SUBSURFACE WASTEWATER DISPOSAL SYSTEM APPLICATION

Street Subdivision Lot #: Spring Road

NEW SYSTEM VARIANCE REQUEST

SUBJECT: New System Variance approval, Kilmer property, Spring Road,
Augusta

SUBSURFACE WASTEWATER DISPOSAL PLAN

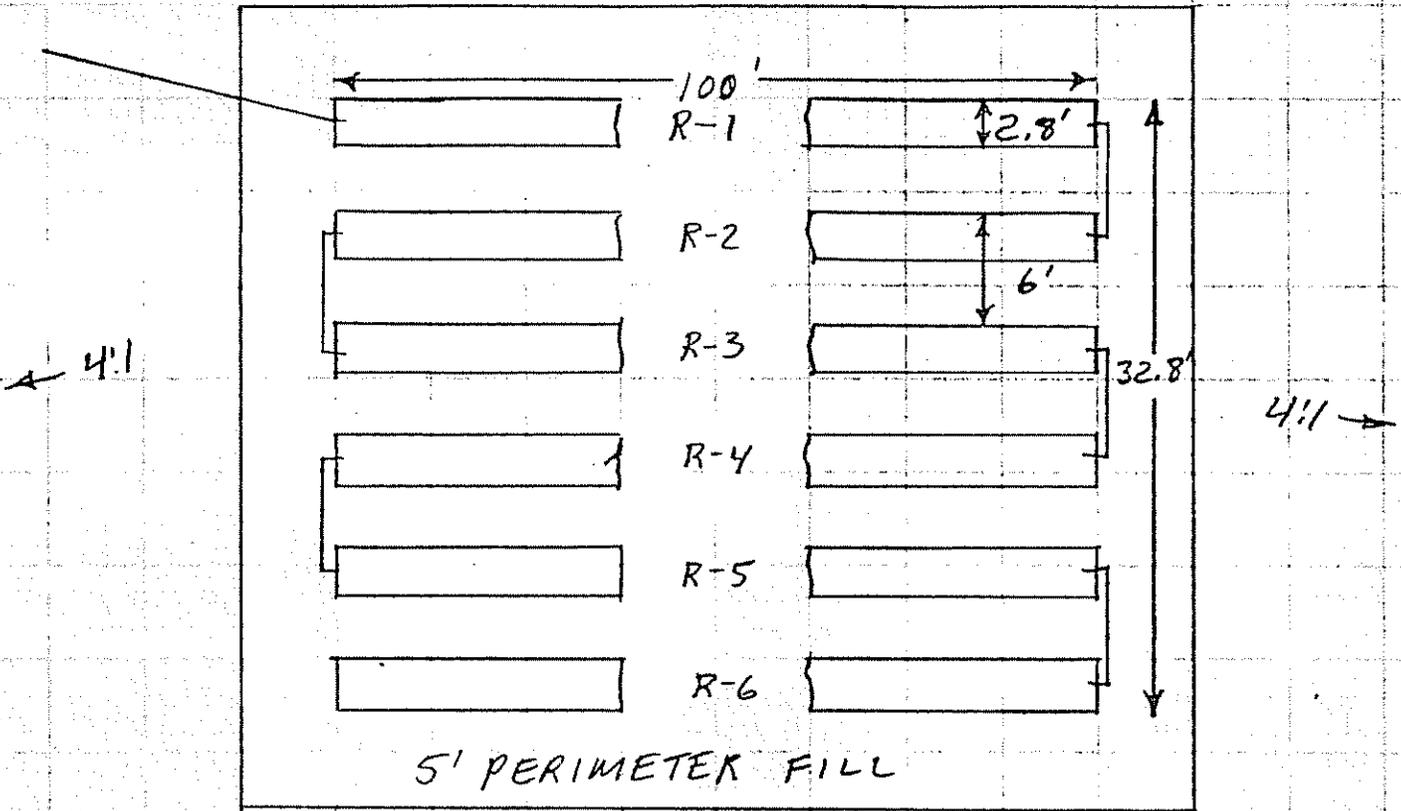
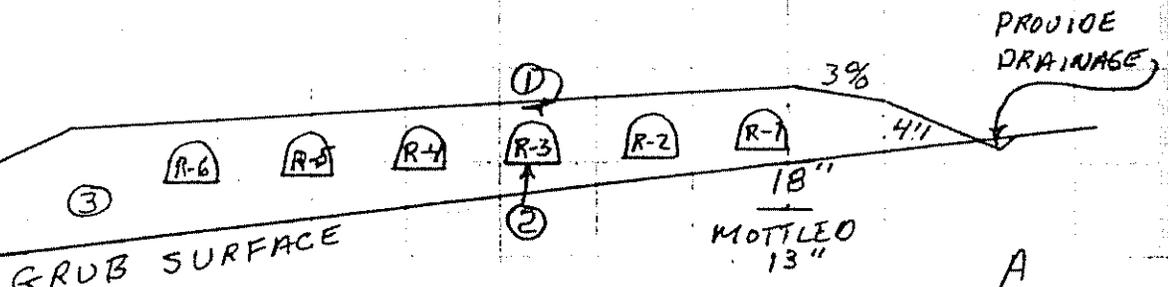
1. INFILTRATORS ON 9-0 SOIL T-16-1, T-6-1
2. _____
3. _____

To allow a disposal system to be installed on soils that do not meet the minimum criteria. Specifically, the seasonal high groundwater table is located 13 inches below grade.

The Division approves of the application dated August 1, 1987 by William W. Rideout, S.E.

Mr. Rideout shall be retained to establish the system location and elevation at the time of construction.

Gary R. Fuller, the Local Plumbing Inspector shall issue a permit prior to the system's installation. The system shall be constructed in compliance with the submitted application.
